Architectural Commission Report

Meeting Date: Wednesday, April 16, 2014

Subject: **9944 SOUTH SANTA MONICA BOULEVARD**
Request for approval of a façade remodel to an existing commercial building. The Commission will also consider adoption of a Categorical Exemption, pursuant to the California Environmental Quality Act. (PL1404805)

Project agent: David Louis Swartz – HLW International

F4 North Elevation (COLOR) ARB

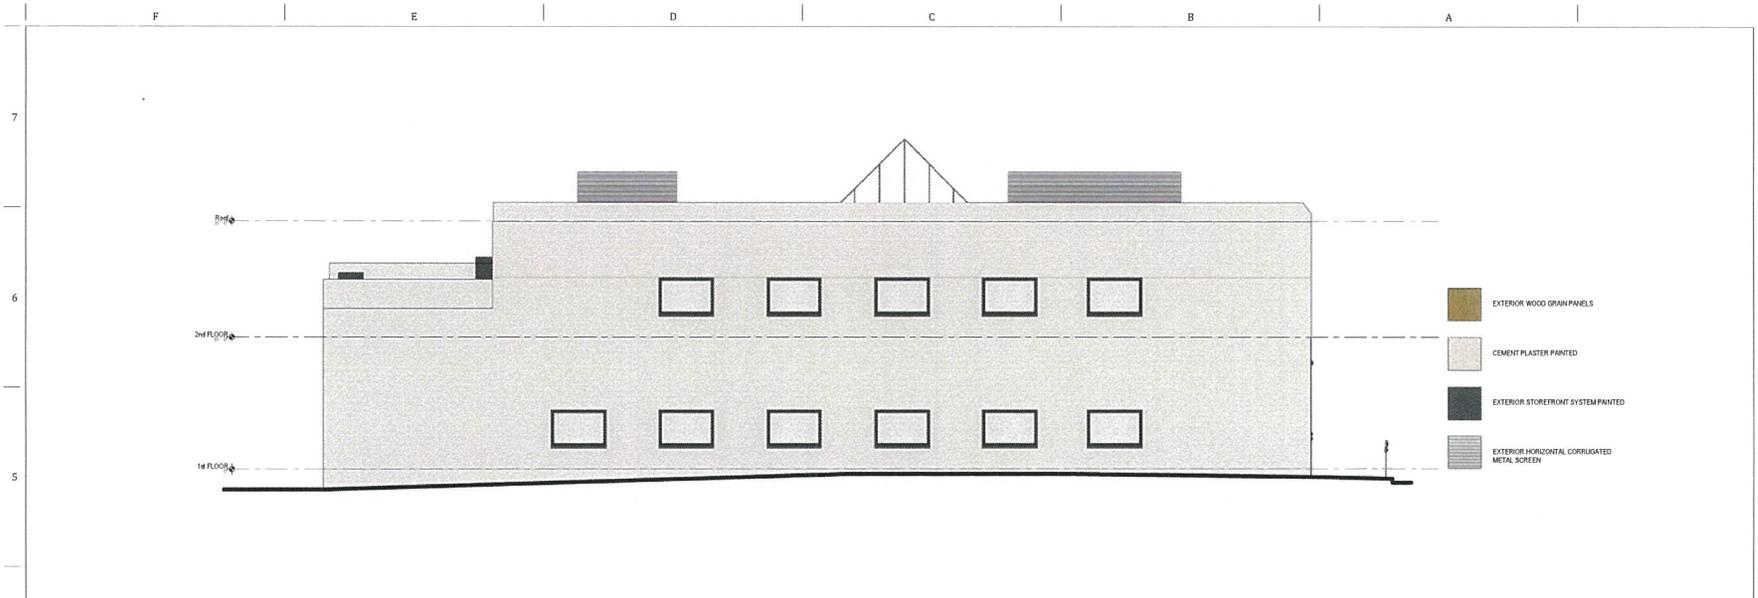
The proposed wood grain panel material is not an appropriate material for the building and does not relate to the overall aesthetic or architectural style of the building. It is recommended that an alternative material be considered that is more appropriate to the façade aesthetic.

Additionally, the ground floor windows adjacent to South Santa Monica Boulevard should be further recessed, as opposed to being flush with the façade, to more appropriately integrate with the adjacent door. Such windows should either extend to the adjacent grade or utilize a 45-degree slanted sill design element. Furthermore, the applicant should develop details for the building's architectural and security lighting.

F4 East Elevation (COLOR) ARB
3/16" = 1'-0"

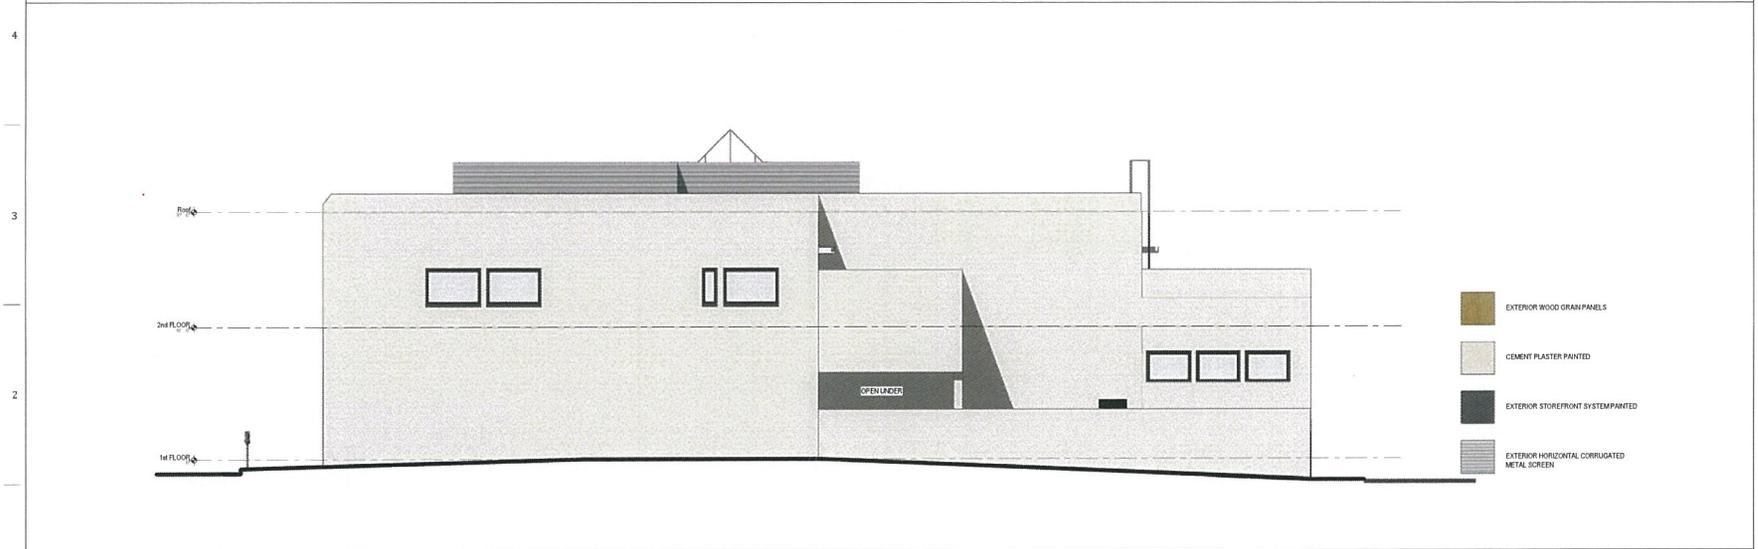
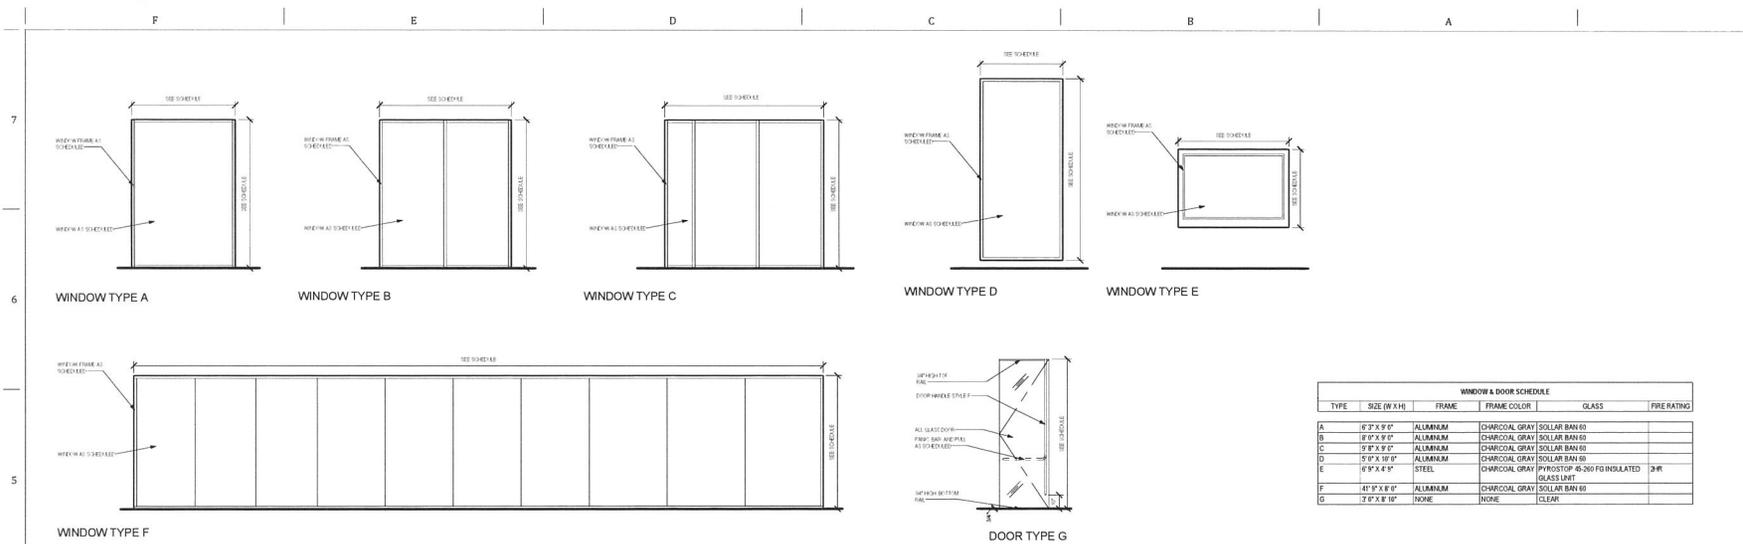
Note: The increased wall height for the outdoor patio located directly adjacent to the rear property line will have to be set back a minimum of 6'-0" so as to meet development standards for properties located in the commercial and residential transitional area. Alternatively, the applicant may choose to maintain the height of the existing patio wall and clad it in a new material with no additional setback requirements.
